# **Groundwater Application Review Summary Form**

Application # G- <u>19221</u>
GW Reviewer Phillip I. Marcy Date Review Completed: _04/19/2023_
Summary of GW Availability and Injury Review:
$\Box$ Groundwater for the proposed use is either over appropriated, will not likely be available in the amounts requested without injury to prior water rights, OR will not likely be available within the capacity of the groundwater resource per Section B of the attached review form.
Summary of Potential for Substantial Interference Review:
oxtimes There is the potential for substantial interference per Section C of the attached review form.
Summary of Well Construction Assessment:
$\square$ The well does not appear to meet current well construction standards per Section D of the attached review form. Route through Well Construction and Compliance Section.
This is only a summary. Documentation is attached and should be read thoroughly to understand the

MEM	0								April 19	, 2023_		
TO:		Applica	oplication G- <u>19221</u>									
FRON	И:	<b>GW:</b> _P	<b>hillip I. I</b> Reviewer									
SUBJ	ECT: S	Scenic Wa	aterway	Interf	erence l	Evaluat	ion					
	YES NO		source (erway o		-	is hydr	aulica

#### Water-Level Measurements in Nearby Wells

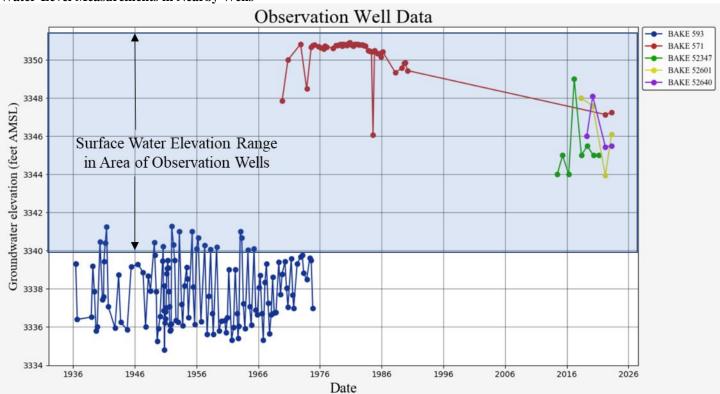
Limited water level data are available for the area surrounding the proposed POA wells. Available data at distances greater than one mile are likely to be representative of the trends at the POA locations, which do not suggest excessive declines. Small decreases in head elevations in a poorly confined system, however, may have implications for surface water availability. See below map for well locations.
